Docket Item # 6  
BAR CASE # 2008-0240

BAR Meeting  
January 7, 2009

**ISSUE:** Alterations / Signage  
**APPLICANT:** Rue Roi, LLC (Victoria Vergason, Agent)  
**LOCATION:** 1015 King Street  
**ZONE:** KR / King Street Urban Retail Zone

Figure 7: "Notched" Picket Balustrade

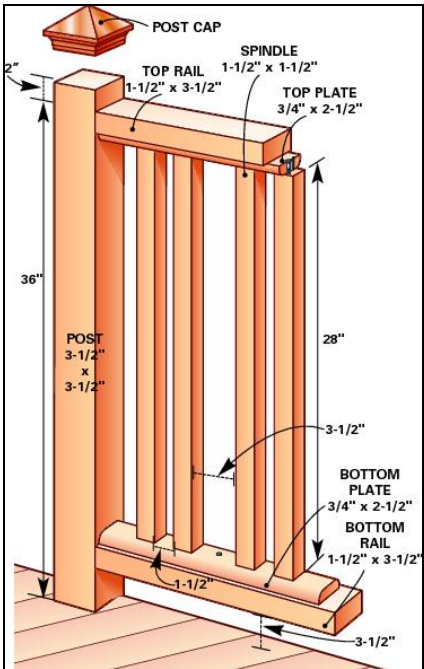
A rear deck affixed to the rear façade of the shed roof extension will provide egress from the second floor of this retail use. The deck will only be visible from the public alley and will not be visible from any of the public roadways. However, the design of the deck's balustrade is a concern, as it is being detailed as a "notched" picket, instead of an "inset" picket balustrade. The notched picket is a detail that is more common in a contemporary subdivision home, and not appropriate for a late 19<sup>th</sup> century building. It is recommended that the Applicant revise the balustrade design to a simple square, inset picket design (see page 12 for an example). Additionally, the *Design Guidelines* require that decks are painted or stained. As such, it is recommended that the Board support a condition of approval whereby this deck is painted to match the trim color utilized on the building's rear façade.

1. That the wood deck's balustrade be an inset picket. The details will be developed for the permit set of drawings to be stamped by Staff;
2. That the wood deck and balustrade will be painted to match the rear exterior trim;
3. That the thresholds of the new doors need to be specified on the permit set of drawings as painted concrete or stone;
4. That the 2/2 window to be removed will be stored on site; and
5. That the new design of the offset, wood board-on-board fence to be installed along the rear, north and west property lines will be developed for the permit set of drawings to be stamped by Staff.

**Figure10: Suggested “Offset” Board-on-Board Fence**

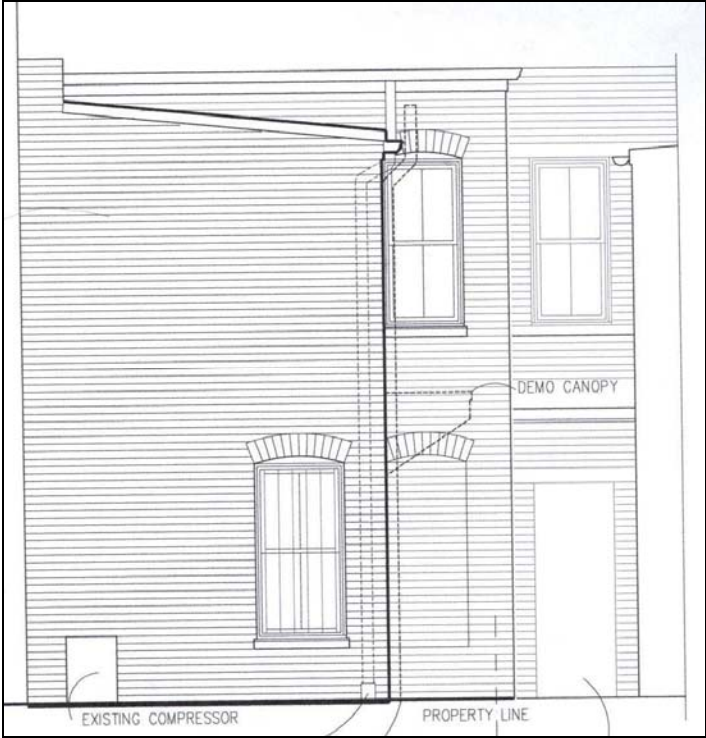
It has been the policy of the Board to support fencing that is not completely solid in design. It is recommended that the Applicant modify the fence design from the proposed solid Board-on-Board fence to an offset Board-on-Board fence (see page 13 for an example).

Figure 12: Proposed North Elevation

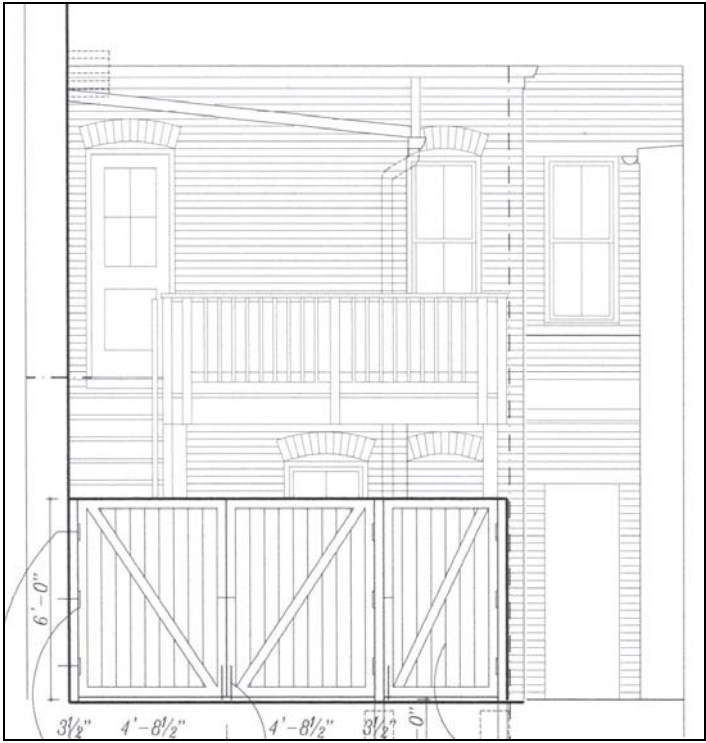
The second floor door is being installed on the rear elevation where currently there is no penetration into the wall surface. The design proposes installing a modern, flat panel, four-light, simulated divided light, wood door capped with a new, brick segmental arch to match the existing fenestrations. The application does not specify the material for the door's threshold. As such, it is recommended that this threshold be a painted stone or concrete, as the historic thresholds currently on the extension are wood, and a stone or concrete threshold would provide the needed differentiation detail for this door.

Figure 14: Proposed West Elevation

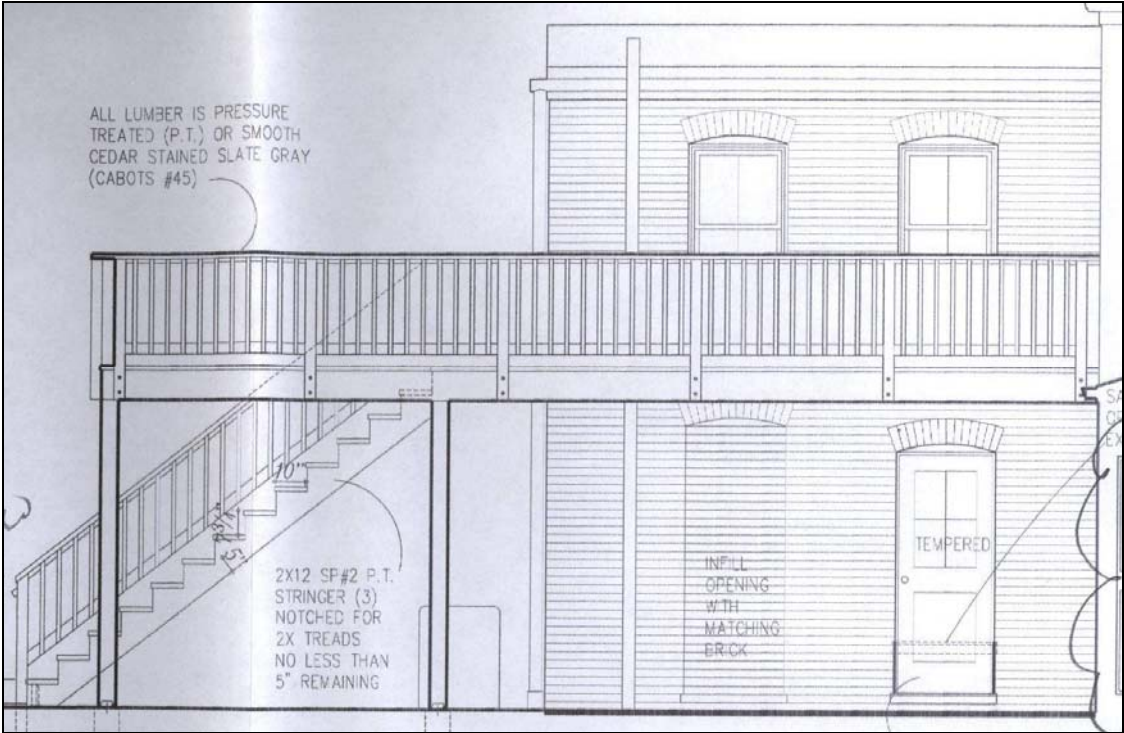
The proposed removal of the 2/2 window and extension of the window sill for the installation of a new door, is a sympathetic way to convert a window into a door. The existing segmental arch and the majority of the window opening are being retained. A small section of the brick below the current sill is required to be removed for this door installation. The remaining window opening and its segmental arch will remain intact. To retain the possibility to revert this door back to a window, it is recommended that the window be removed with its framing intact and stored on-site. It is also recommended that this new door's threshold be fabricated of stone or concrete.

The existing door on this elevation proposes to be enclosed with brick. However, the original brick segmental arch will be retained and a ghosting of this opening will be visible.
